**Rancho Las Virgenes
Regional Facilities Expansion IV**

Solids Handling and Composting Facilities

LAS VIRGENES MWD / TRIUNFO CSD
RANCHO LAS VIRGENES - REGIONAL FACILITIES EXPANSION IV
SOLIDS HANDLING AND COMPOSTING FACILITIES

ANAEROBIC DIGESTERS AND
 DIGESTER PUMP STATION

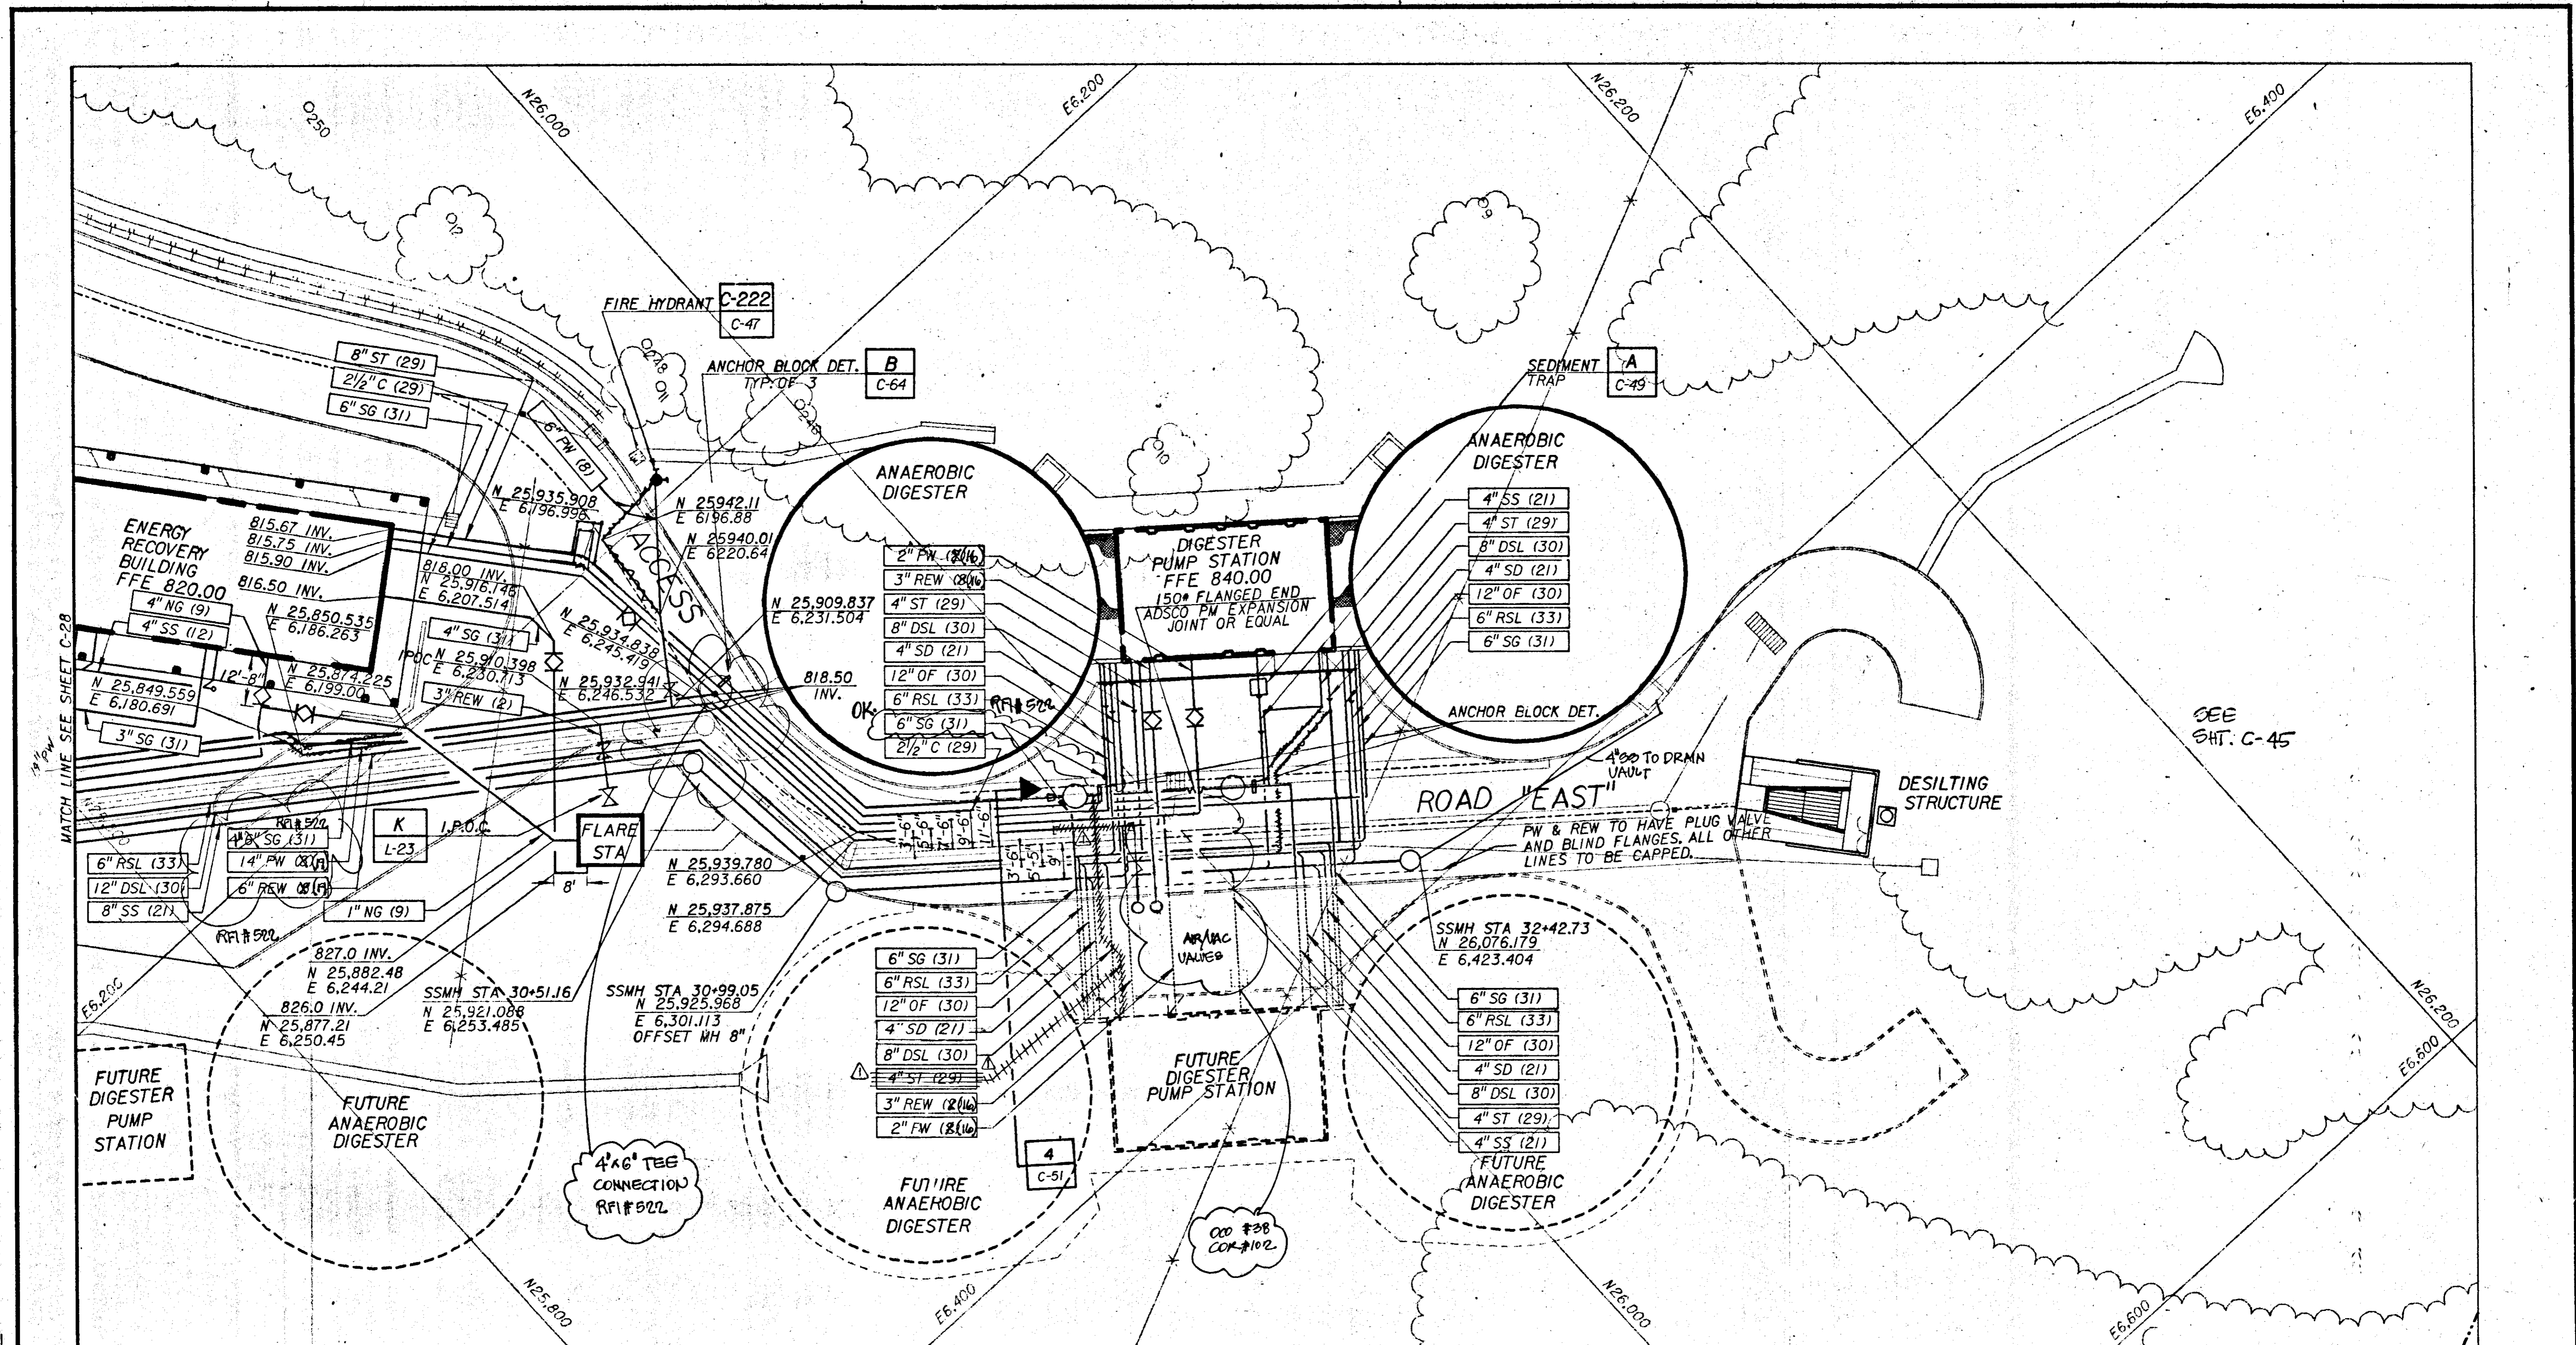
RFI#16
SHUT-OFF VALVES SMALLER THAN 8" IN SIZE, (WITH THE EXCEPTION OF MOTOR OPERATED VALVES), TYPICALLY ARE NOT NUMBERED OR SHOWN ON THE VALVE SCHEDULE (SHT M-12). VALVE TYPES SHALL BE AS SHOWN ON THE DRAWINGS PER SYMBOLS PER SHT. G-G. VALVES SHALL BE AS NOTED ON SHT. N-3 AND AS SPECIFIED IN VALVE SPECIFICATION SECTION 15100 THROUGH 15115. C-25, C-27, C-28

SHEET
 IM-1

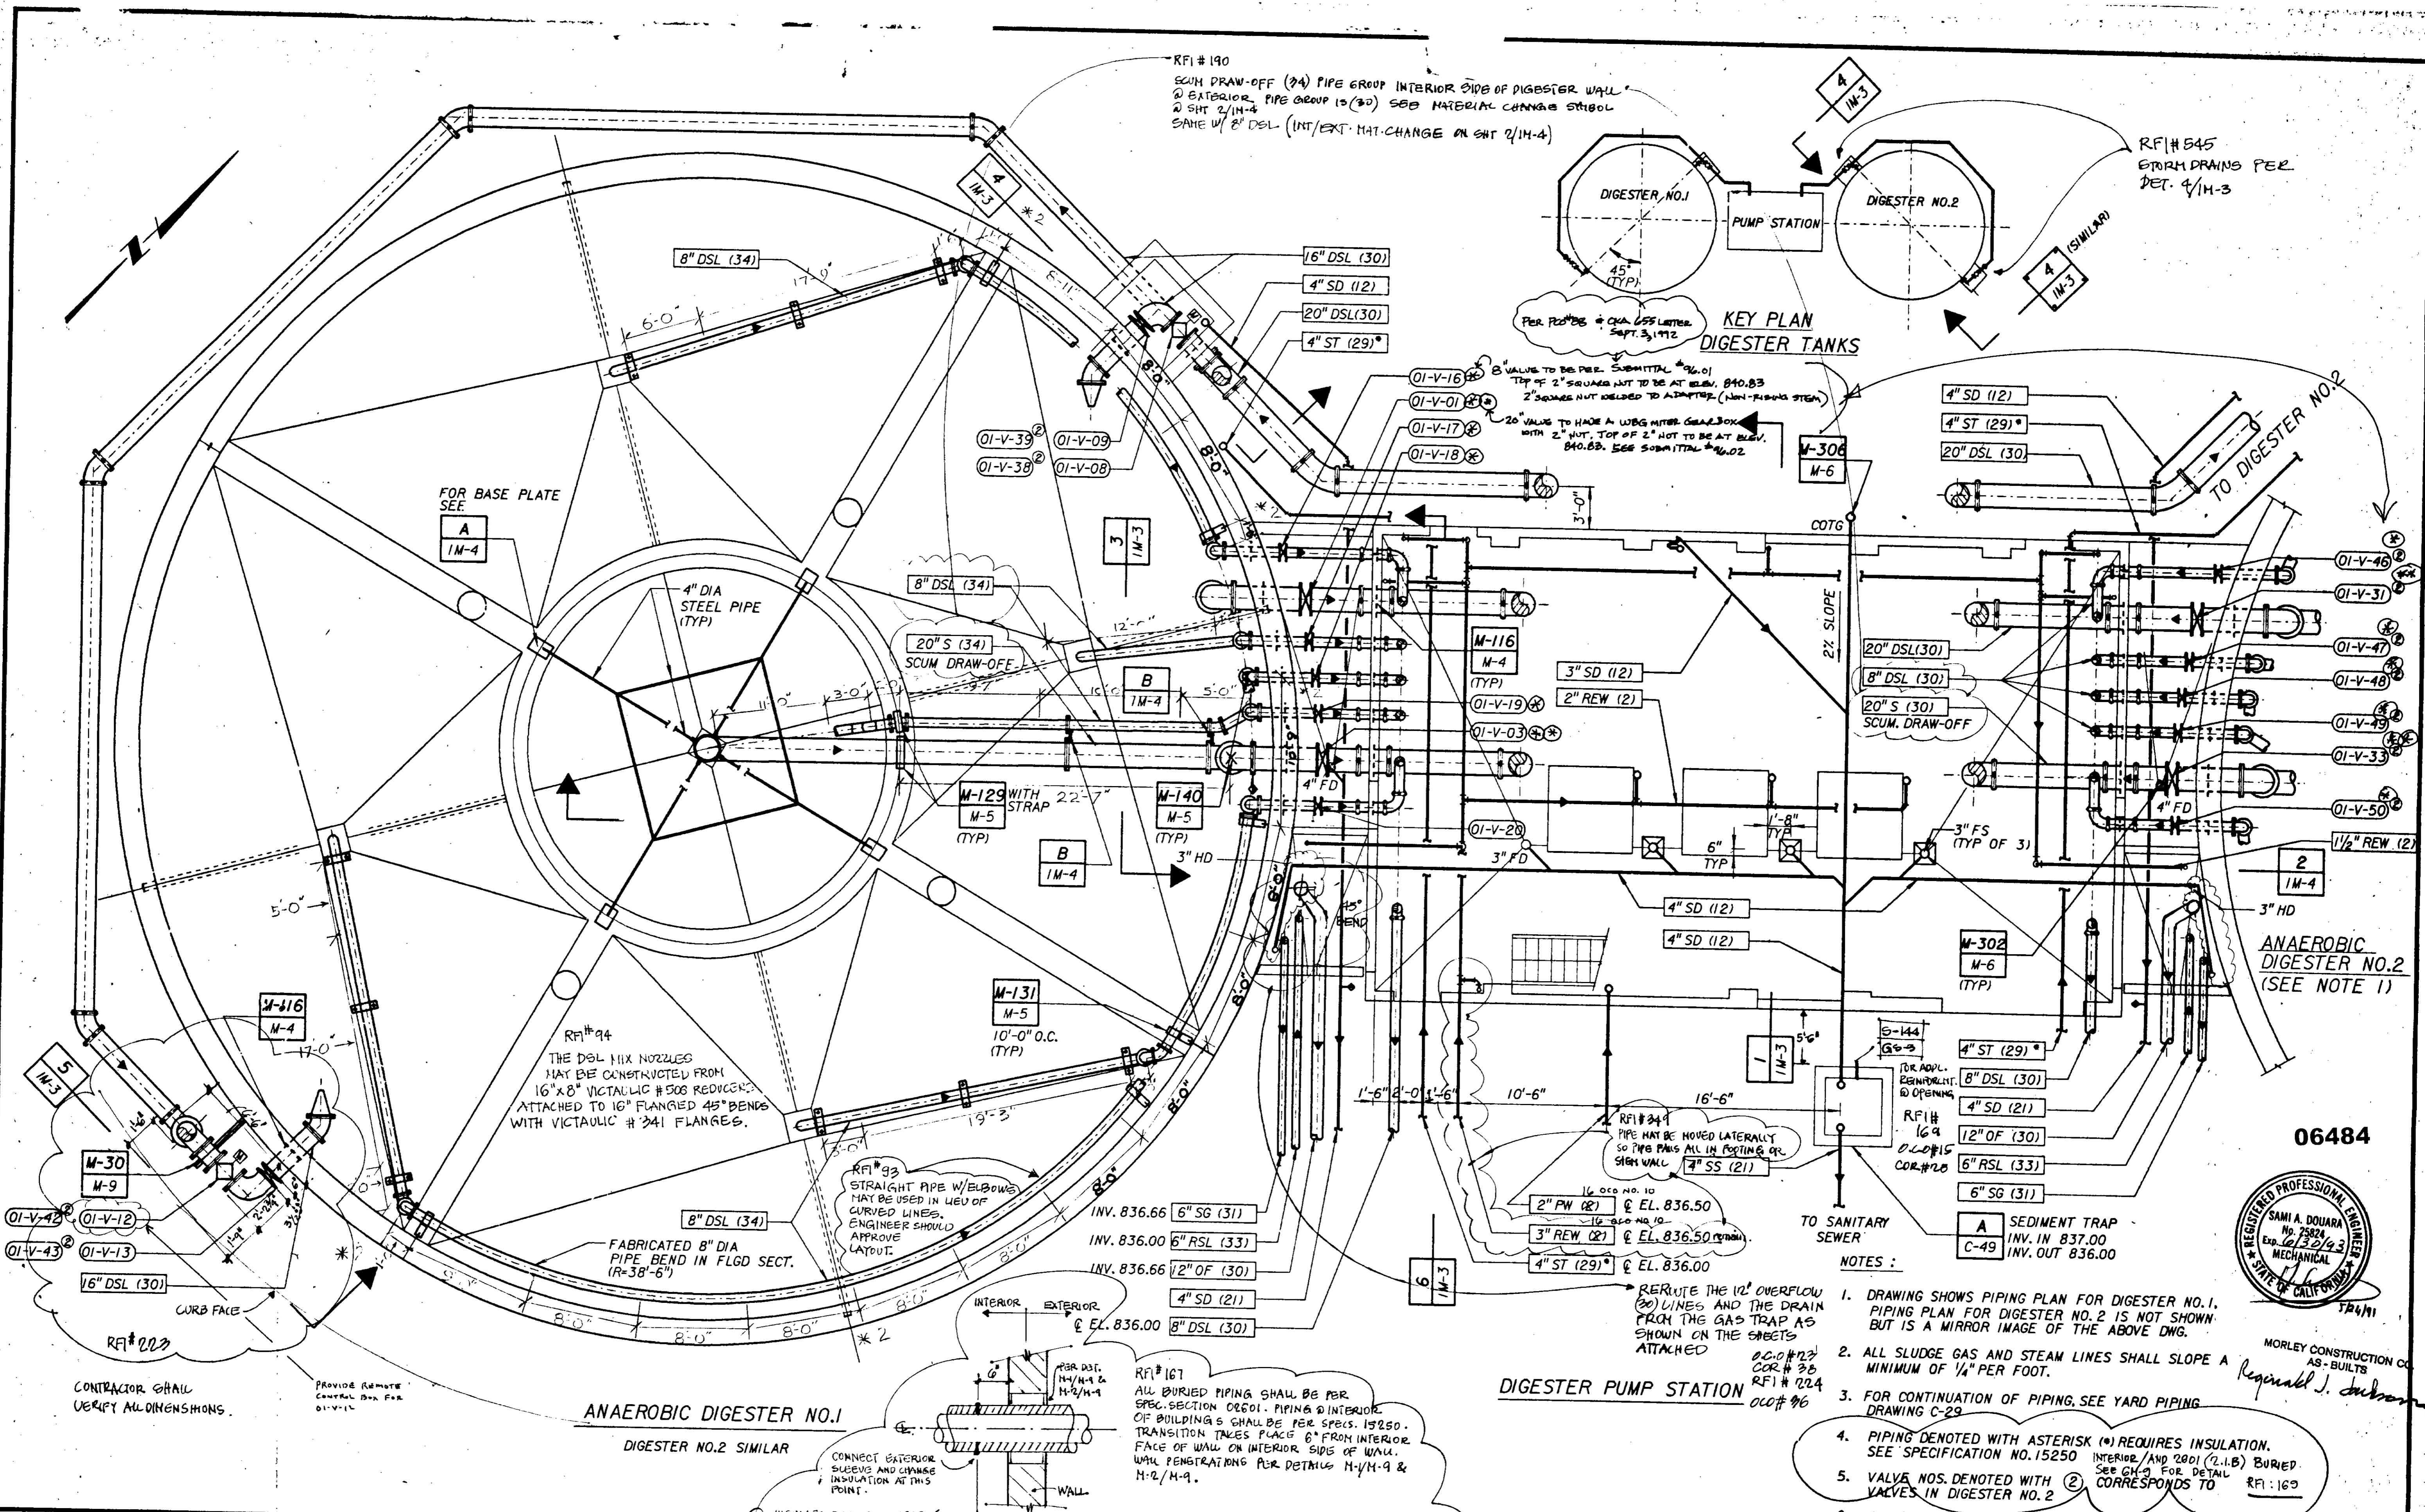
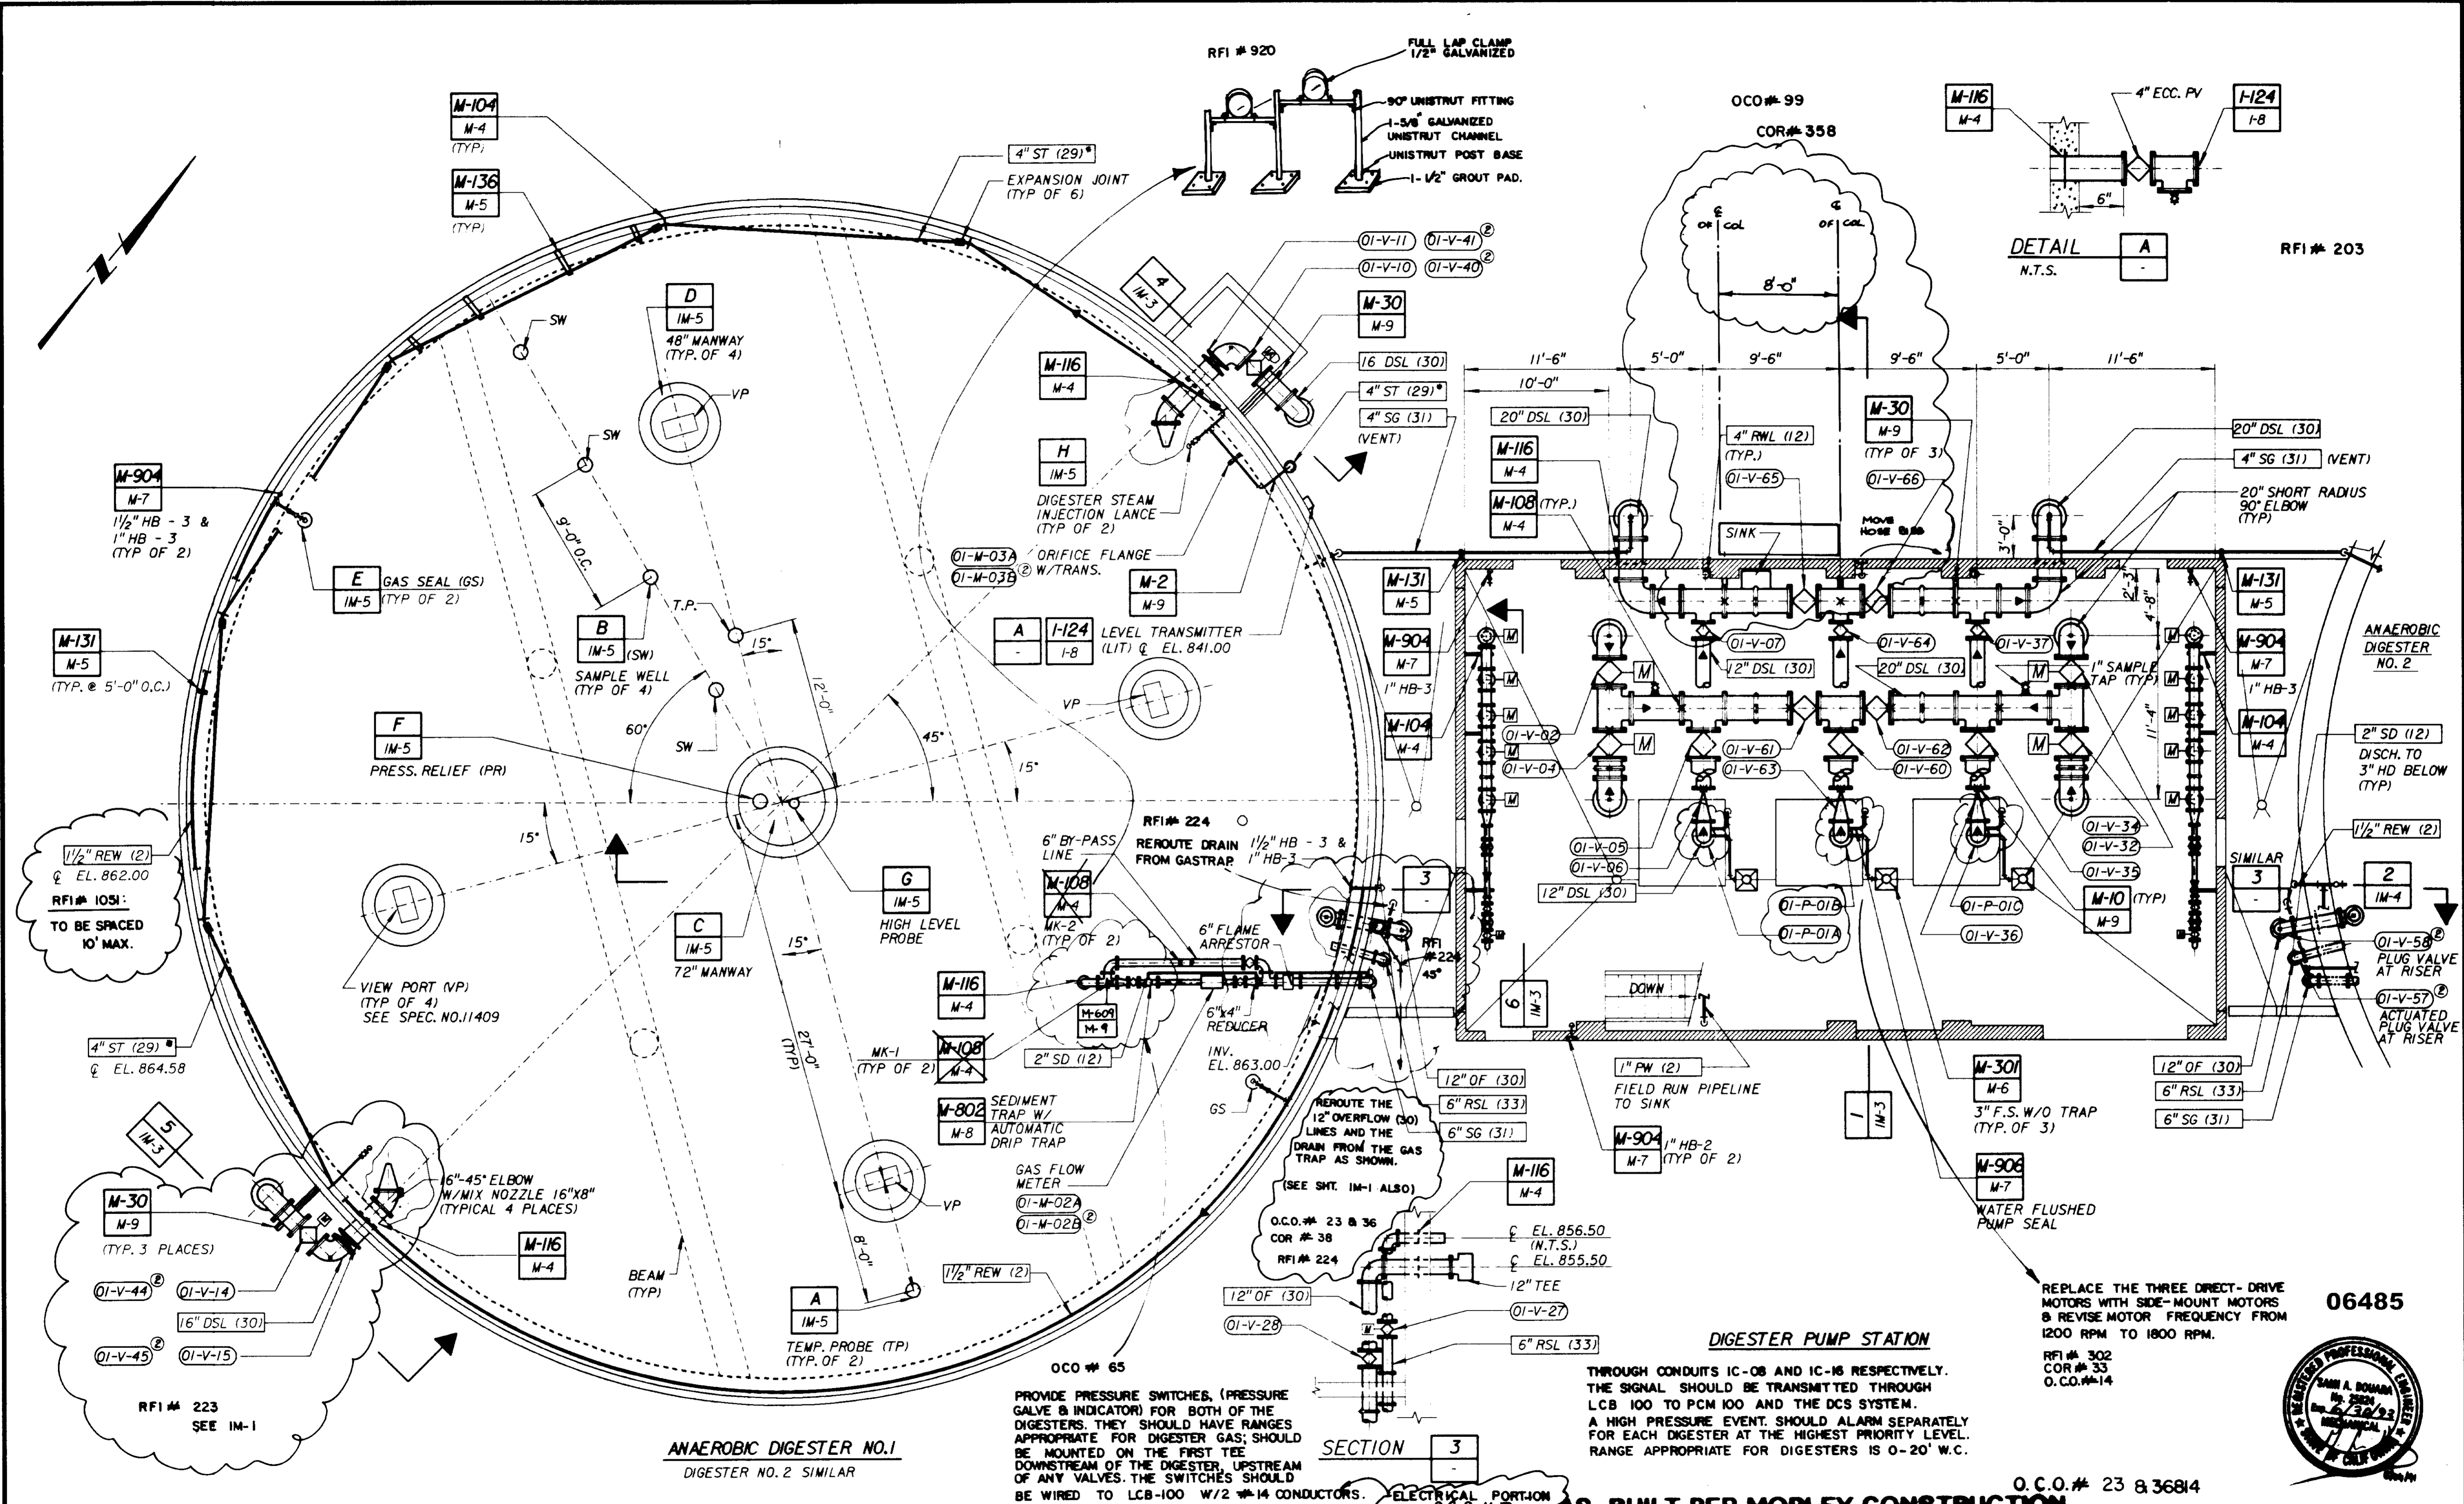
RFI #190
 SCUM DRAW-OFF (24) PIPE GROUP INTERIOR SIDE OF DIGESTER WALL
 2 EXTERIOR PIPE GROUP (20) SEE MATERIAL CHANGE SYMBOL
 2 SH 2/14-4
 SAME W/ 2\"/>

RFI #545
 STORM DRAINS PER
 DET. 4/14-3

RFI #94
 THE DSL MIX NOZZLES
 MAY BE CONSTRUCTED FROM
 16\"/>

RFI #93
 STRAIGHT PIPE W/ ELBOWS
 MAY BE USED IN LIEU OF
 CURVED LINES.
 ENGINEER SHOULD
 APPROVE
 LAYOUT.

RFI #349
 PIPE MAY BE MOVED LATERALLY
 SO PIPE PANS ALL IN FOOTING OR
 SIGN WALL
 7\"/>
